PLANNING BOARD

Tuesday, August 11, 2026 at 4:30 PM
Room 24 (Basement Level of City Hall)
and Zoom

- i. Major Site Plan; 41 Ashmont Street; 509 Forest LLC, Applicant. The Planning Board will hold a workshop to consider an application for the construction of two multi-unit affordable apartment buildings in the B-1 zone. The proposed development includes a four-story, 30-unit building and a five-story, 33-unit building, for a total of 63 affordable dwelling units, along with 10 parking spaces.

4 | SOUTH ELEVATION - BUILDING 1
1/8" = 1'-0"

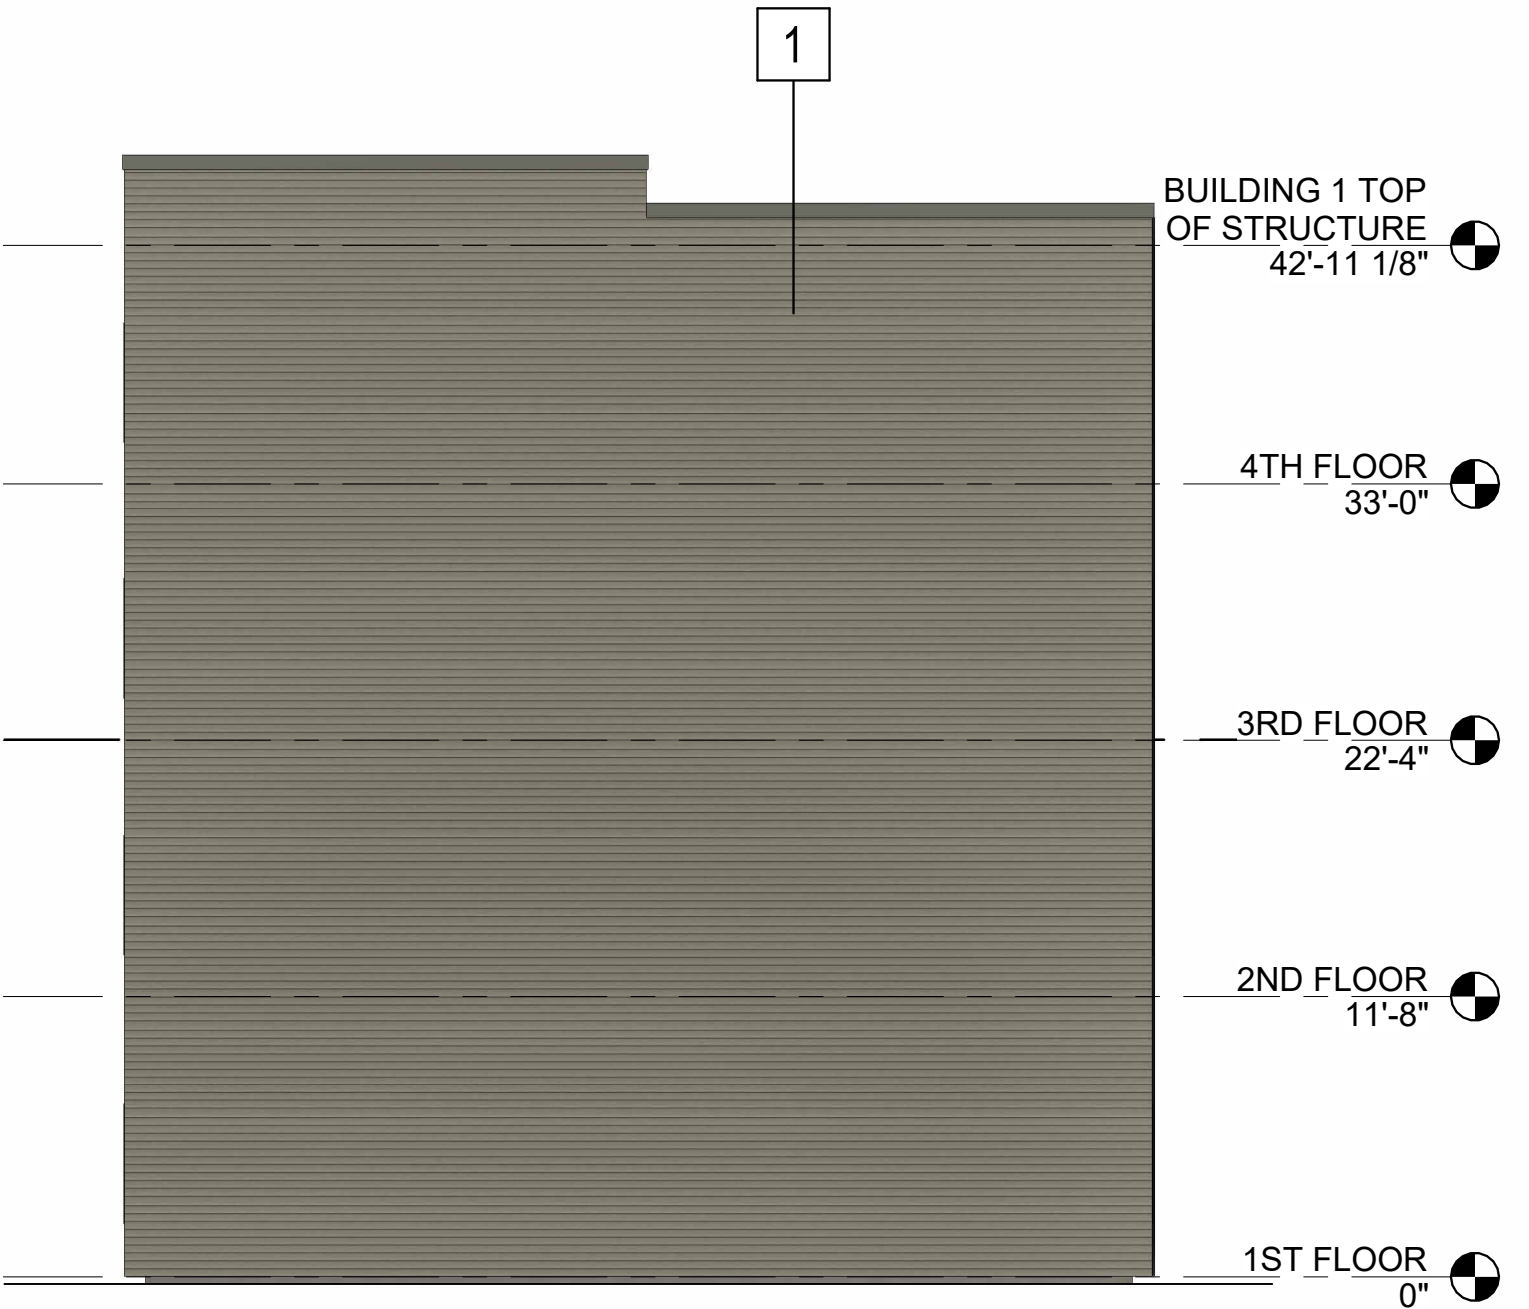
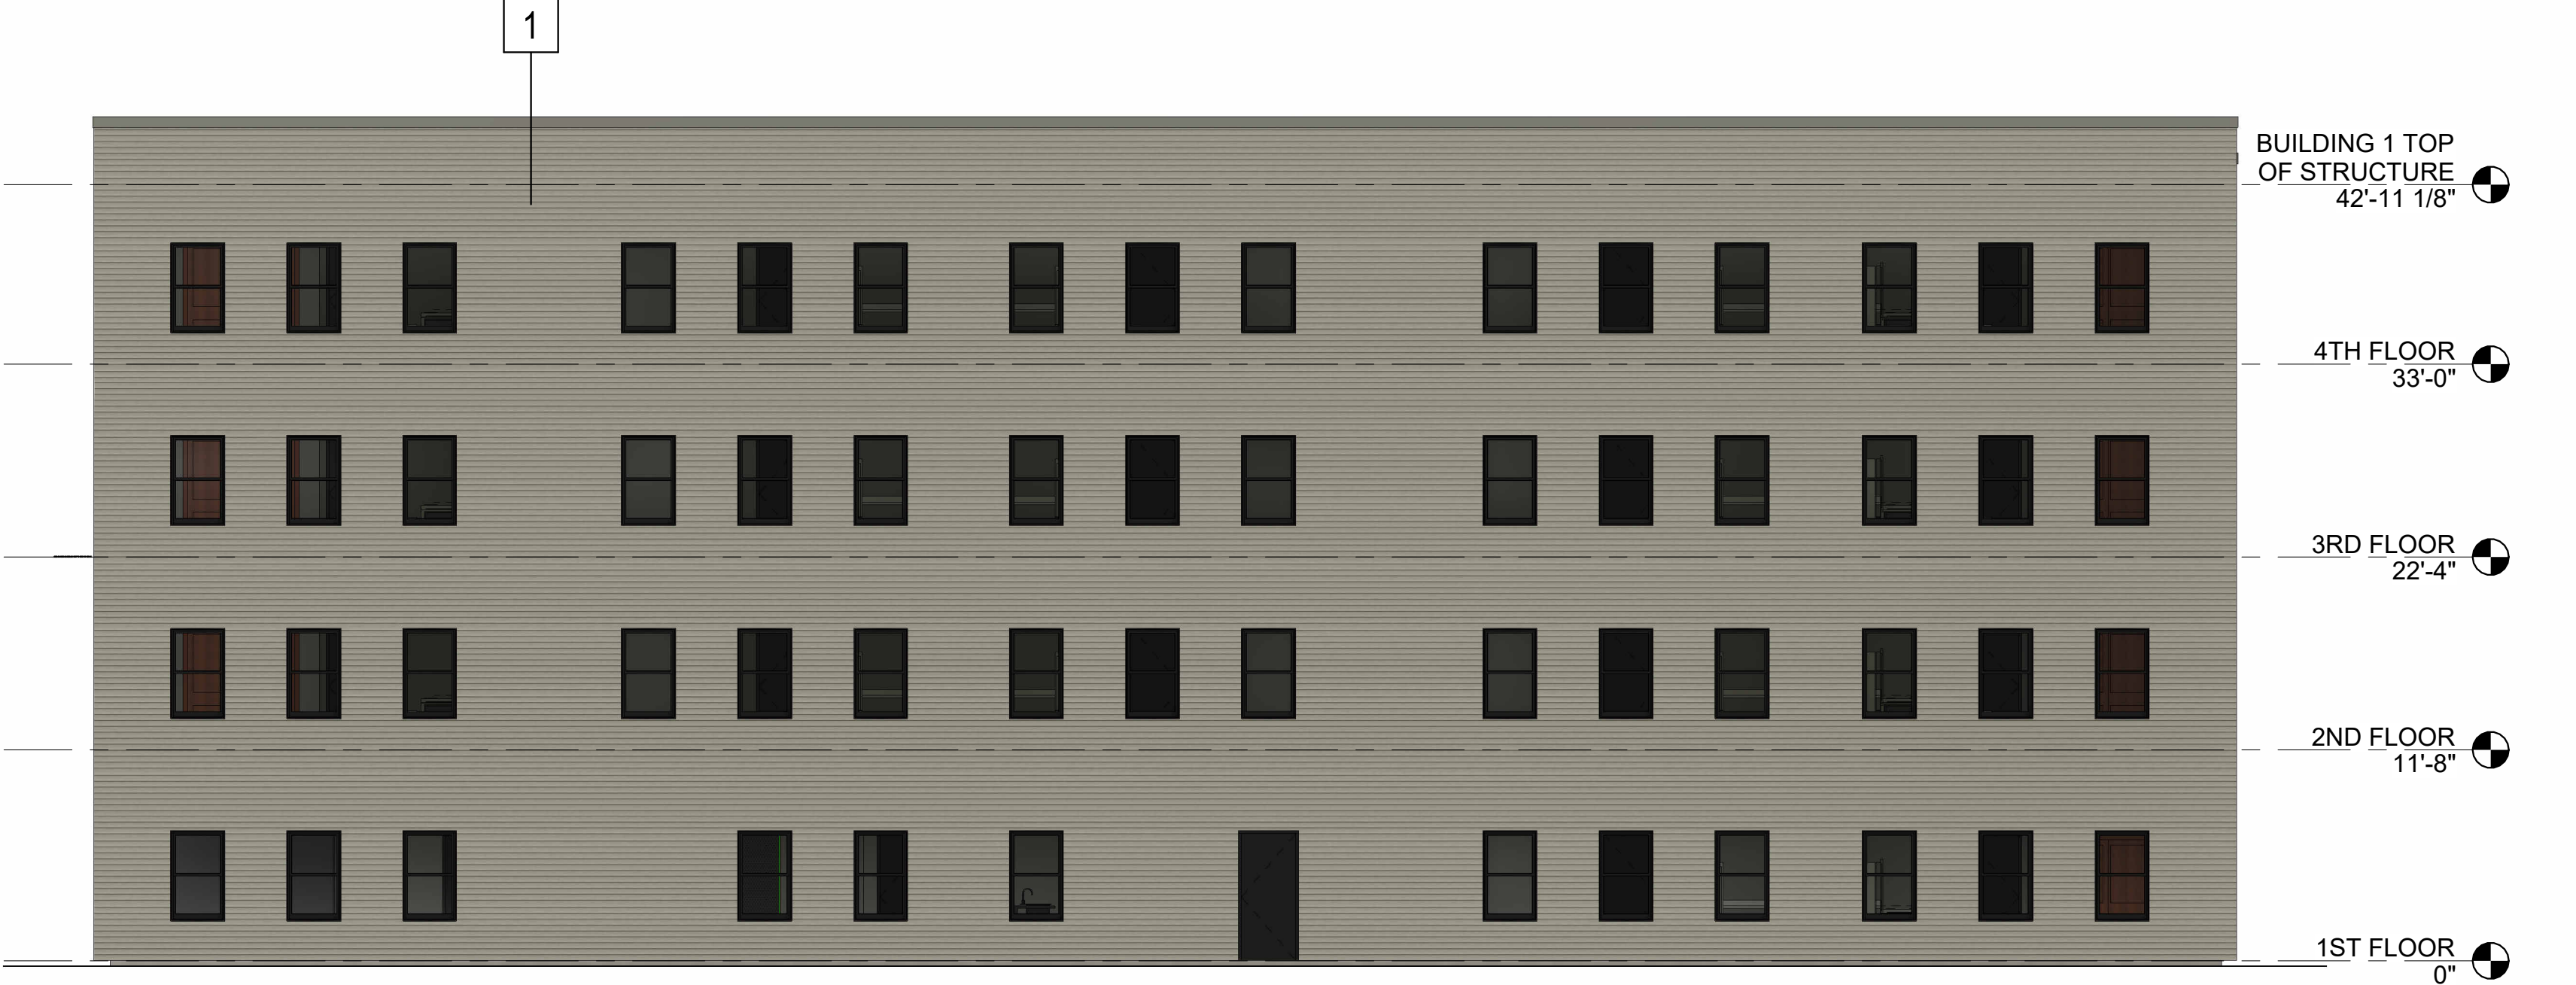
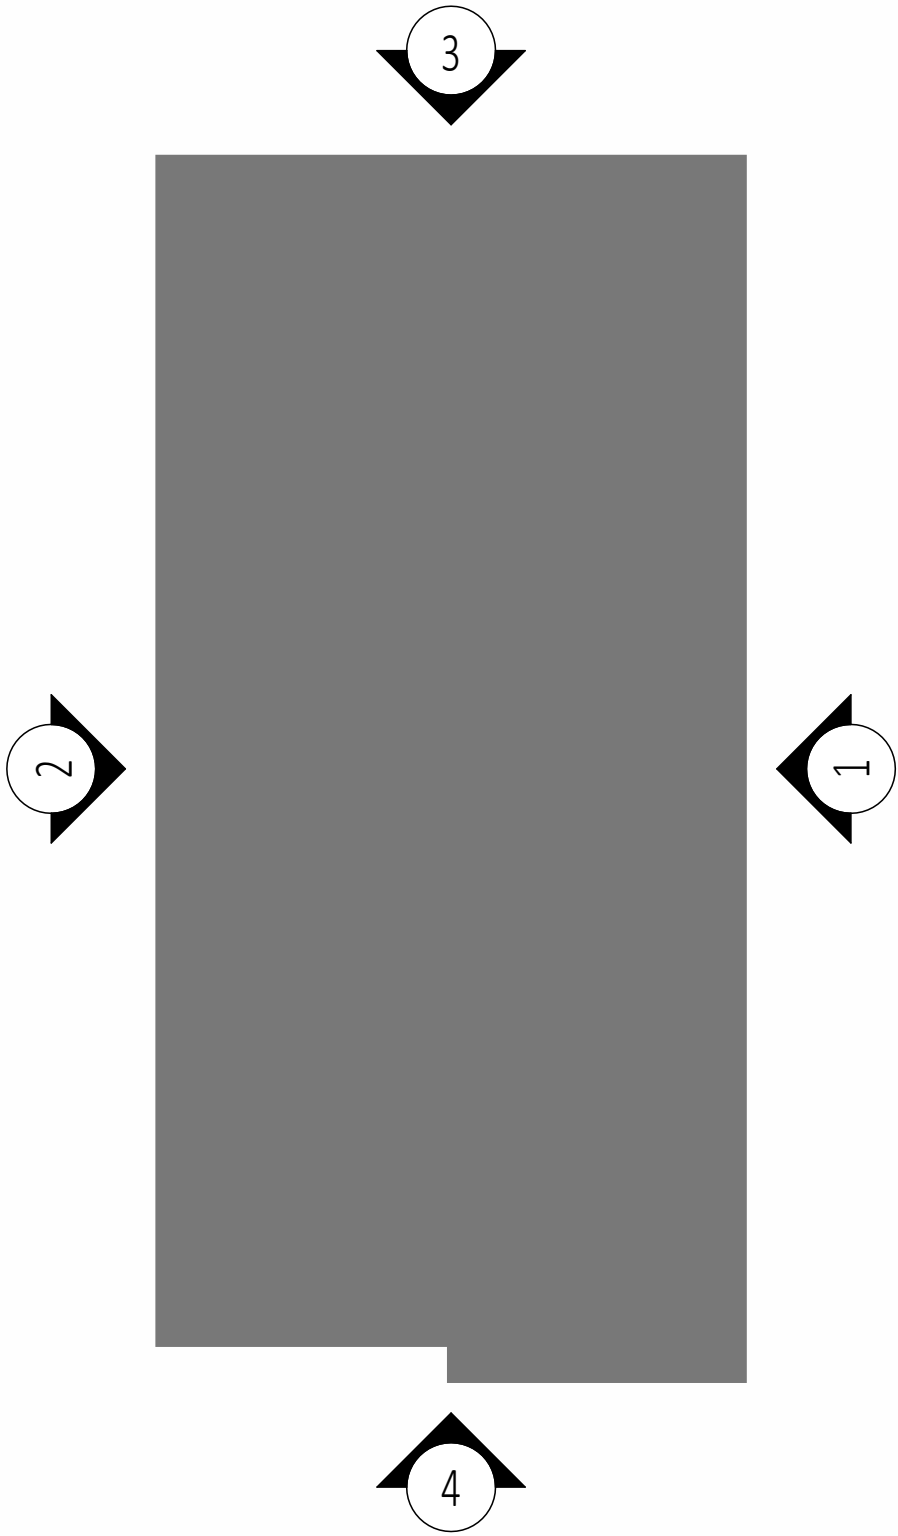
4. Building 1's structure height: the bulk table on Sheet C-3.0 reports 35 feet, but the architectural elevations show "TOP OF STRUCTURE — 42'-11 $\frac{1}{8}$ " on all four faces, with a uniform roofline along the West Elevation. Sheet C-3.0 shows that west wall set back 5 feet from the RN-3 zone, where Table 7-C limits height to 35 feet. (I have raised this separately with staff and would appreciate the answer in the project file.)
5. Parking: the plans provide roughly 10 spaces, for staff, across 63 units, on a street where neighbors already petitioned to restrict parking to one side. I understand § 18.1.2 requires no off-street parking. Will a Transportation
